PRELIMINARY DISCUSSION ONLY
PRELIMINARY DRAWING FOR PLAT OF COUNTRY MEADOWS SOUTH PLAT I
March 2, 2026

Preliminary Discussion of Country Meadows South Plat I (Assumes R-2 zoning, 21 lots, 20.4+/- acres)

COUNTRY MEADOWS SOUTH PLAT 1

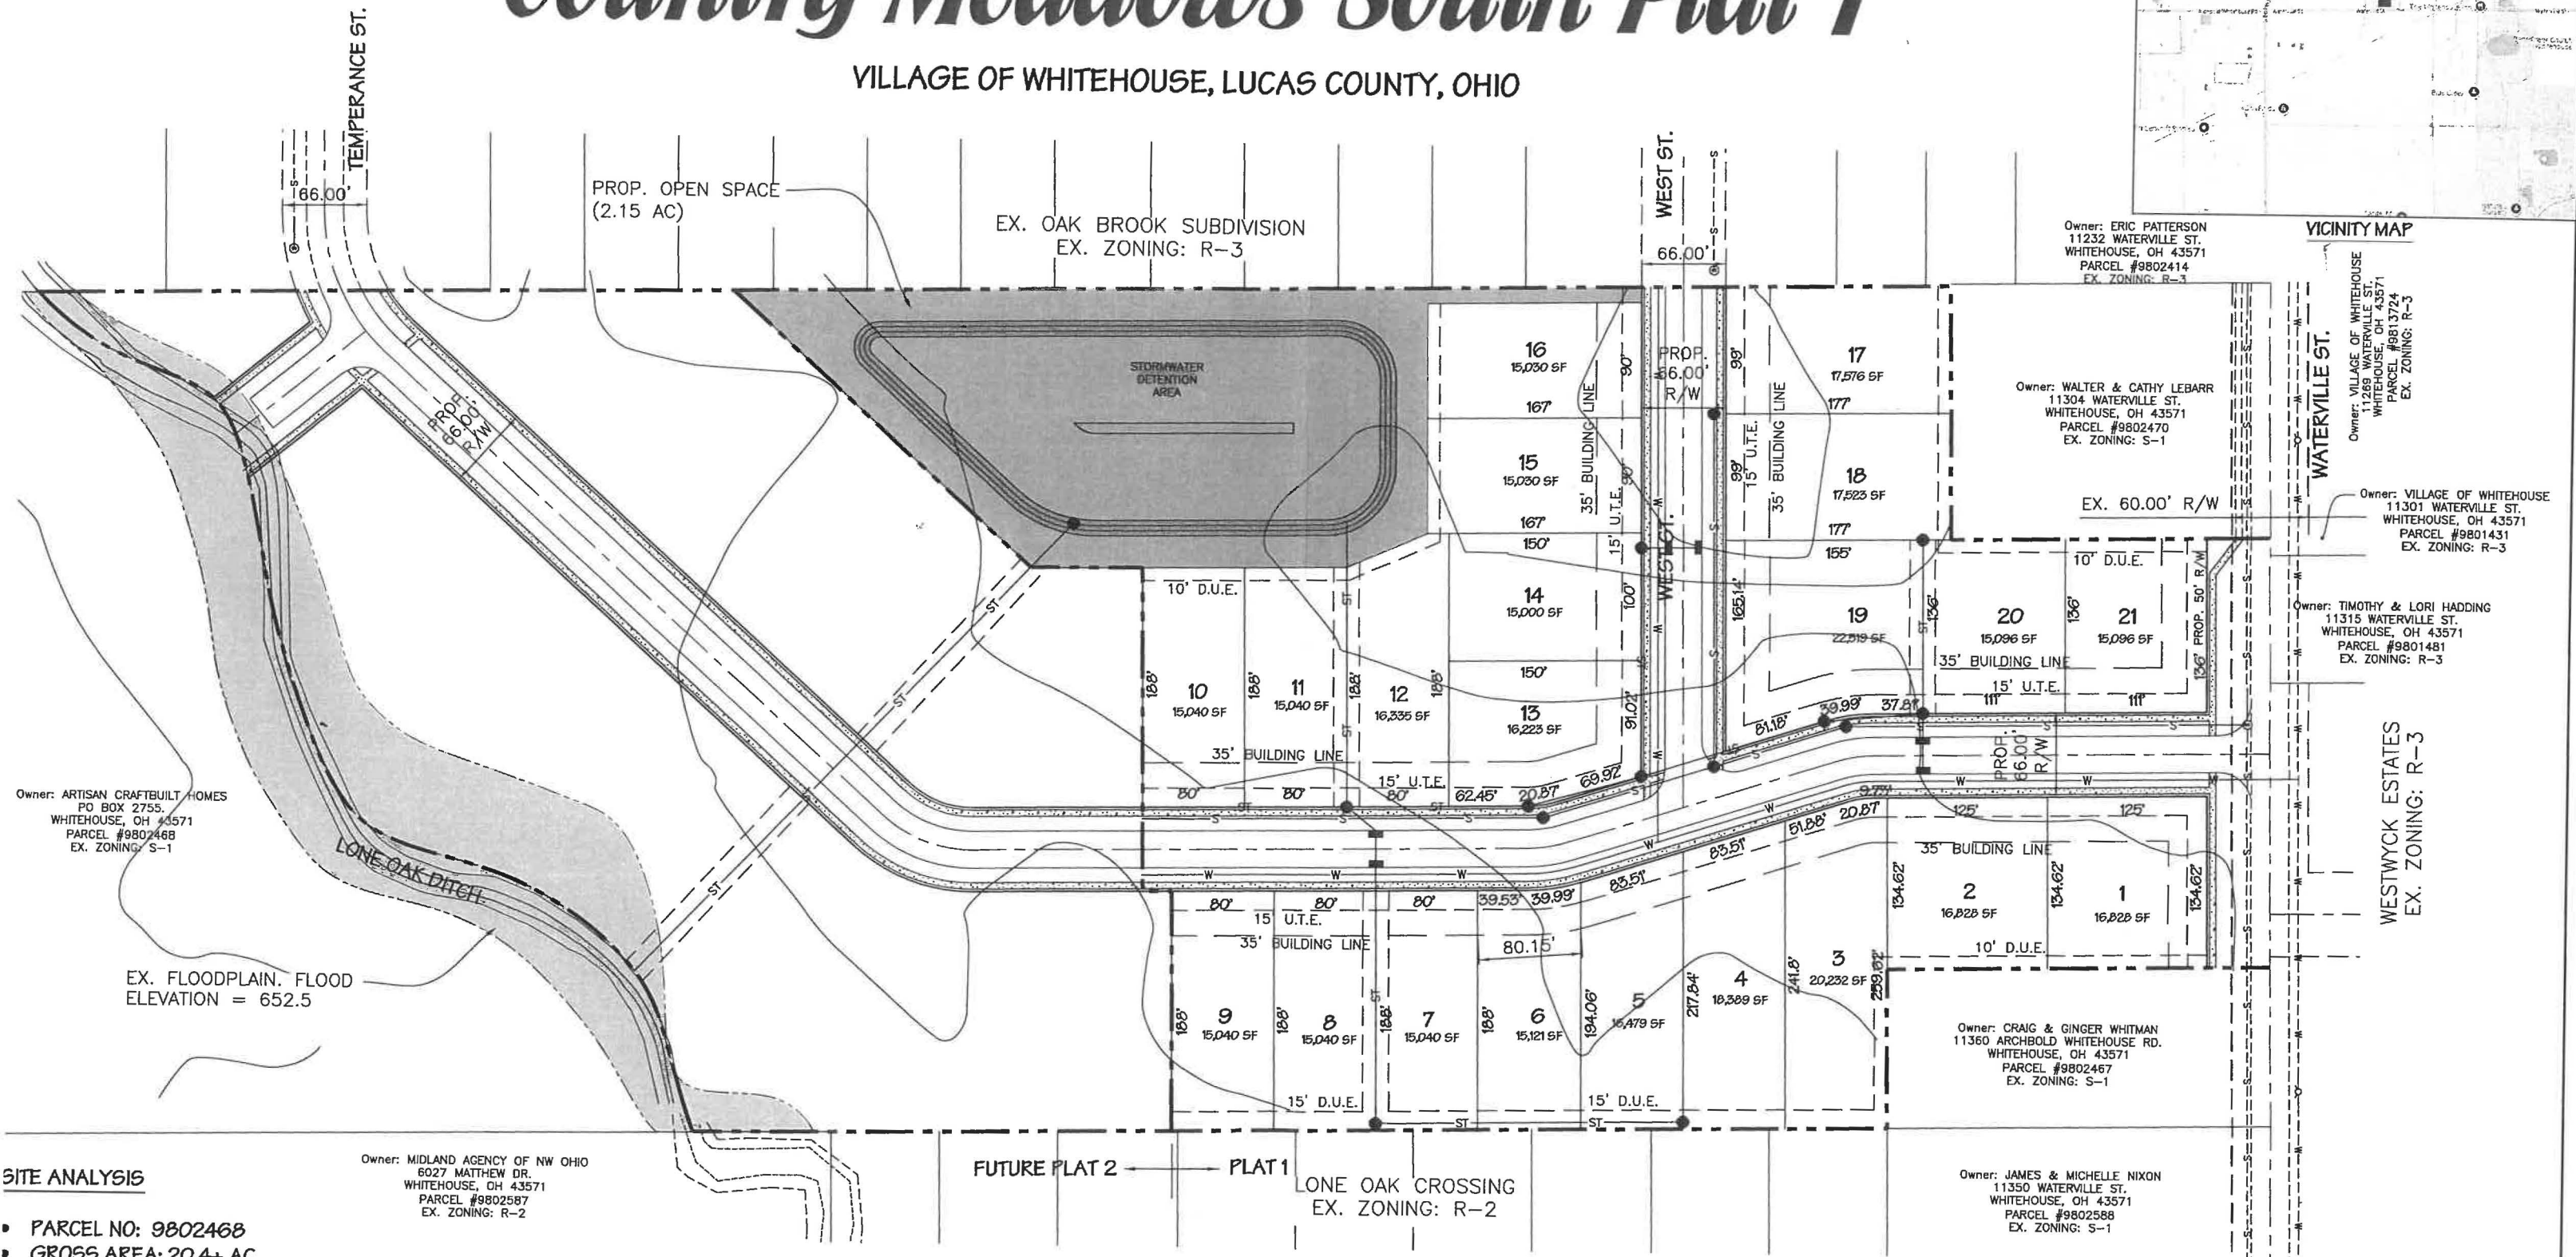
1. Portions in the Village are currently zoned S-1, applicant is proposing R-2. Zoning map amendment will be required for those parcels.
2. 20.4 acres with 21 lots varying in size from 15,000 to 22,519 square feet. Frontages are on both West Street and Cemetery Street.

3. All lots meet the 15,000 square feet area minimum for R-2.
4. All lots appear to meet the a) 35' minimum rear yard setback, b) 35' minimum front building line setback, and c) 10' minimum side yard setback.

5. Lots 3 through 12 have property frontage widths below the 90' minimum. Those parcel width range from 80' to 83.5+/- . Therefore, variances will be necessary.

6. *Subdivision Regulations Chapter 1127.03 (A) ... The street patterns shall include some extensions to the boundaries of the development to provide circulation between adjoining neighborhoods.* It appears this requirement is met.

7. *Chapter 1127.05 (B) "It is recommended that when available, sites be joined by walking trails and/or multi-use paths ... to provide convenient pedestrian access to all portions of the subdivision and other areas in the municipality, such as shopping, parks and schools."* Are interior sidewalks being proposed?

8. The surrounding area is known to flood. Advised to discuss the stormwater detention plan and capacity.
9. A Street Tree Plan will be required.

10. A street lighting plan will be required.

11. The United States Postal Service requires Cluster Box Units (CBU's) as opposed to individual mail boxes.
12. Entrance signs?
13. Maintenance of the large pond and the storm water detention areas.
14. Homeowners Association.
